FIELD CHANGE ORDER	NUMBER: KN03-GA-0001
--------------------	----------------------

All DS5000 Model 240 and DS5900 systems with daughter cards, part number 54-20627-01 OR KN03 CPU daughter cards, part number 54-20627-02 BELOW rev. B01, will need to be replaced by the FCO.

FCO KN03-GA-0001

Figure 1

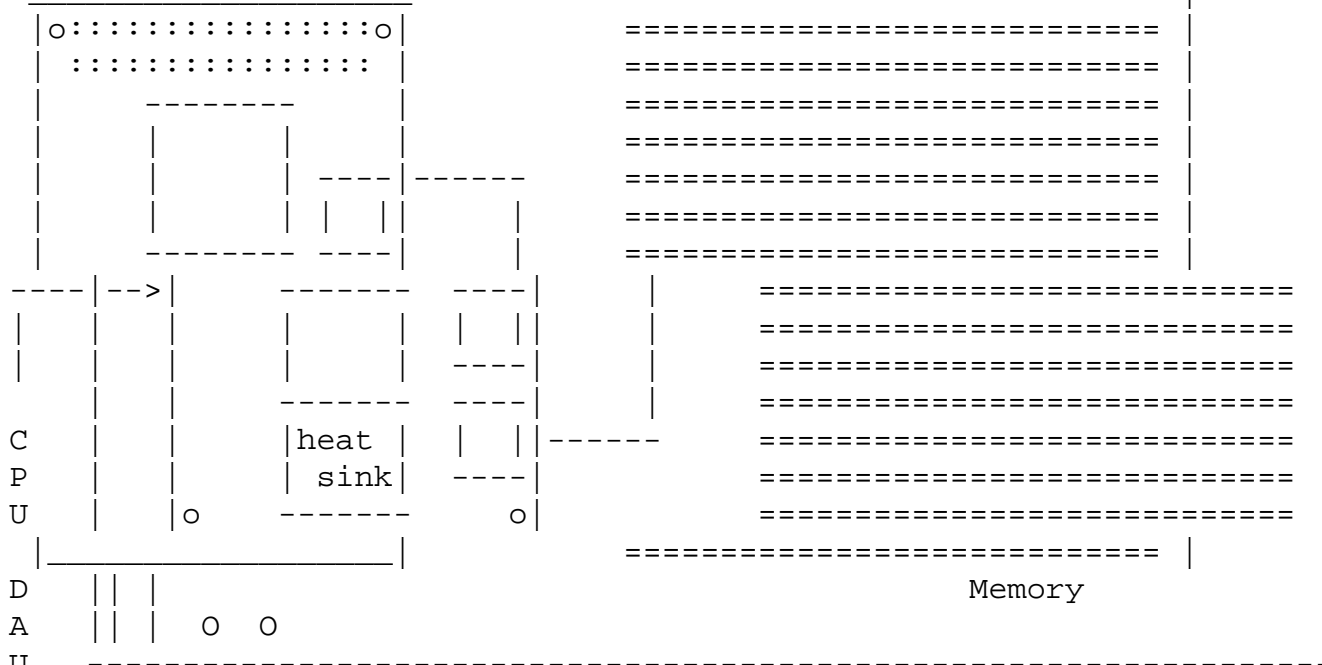
C
A <----- Part number 54-20627-02 should be rev. B01 or higher
R

Install module 54-20627-02 rev. B01 or higher.
